PLAN COMMISSION STAFF REPORT

Agenda Item: PC Docket No. 22-025

Application: **Development Plan**

Summary: Munster Properties LLC requesting approval of a development plan for a medical office building at 10350 Calumet.

Landscaping Plan

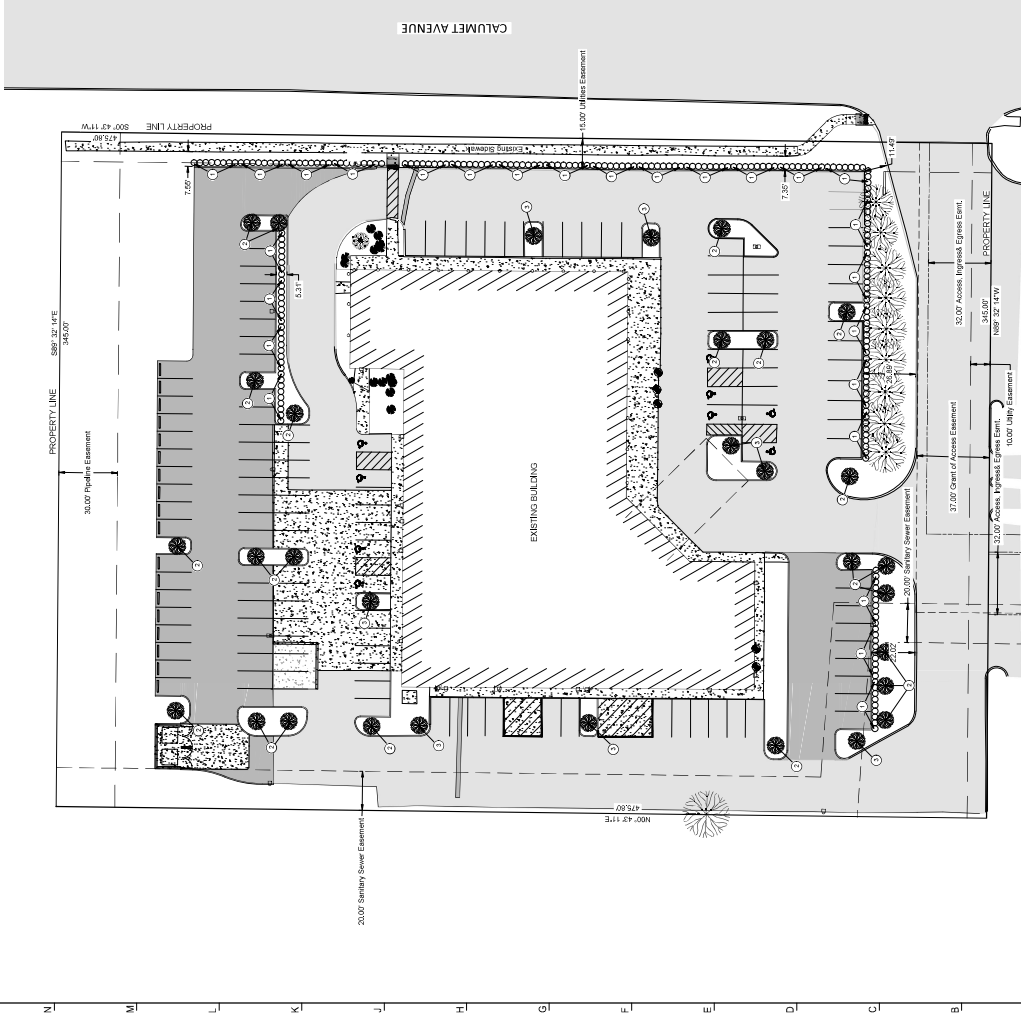
Staff notes that the following additional landscape features are missing and must be added to the plan:

1. An enhanced hedge along the Calumet Avenue frontage, which includes a 3.5' ornamental fence, a continuous hedge, and trees planted 30' on center.
2. A hedge screen along north edge of the property, screening the parking area from the adjacent property.
3. Parkway trees planted 30' on center along Calumet Avenue.

- *The landscaping plan be revised to include:*
 - *An enhanced hedge along the Calumet Avenue frontage, which includes a 3.5' ornamental fence, a continuous hedge, and trees planted 30' on center.*
 - *A hedge screen along north edge of the property, screening the parking area from the adjacent property.*
 - *Parkway trees planted 30' on center along Calumet Avenue.*
- *The lighting plan be revised to include acorn, coach, or colonial-style fixtures.*
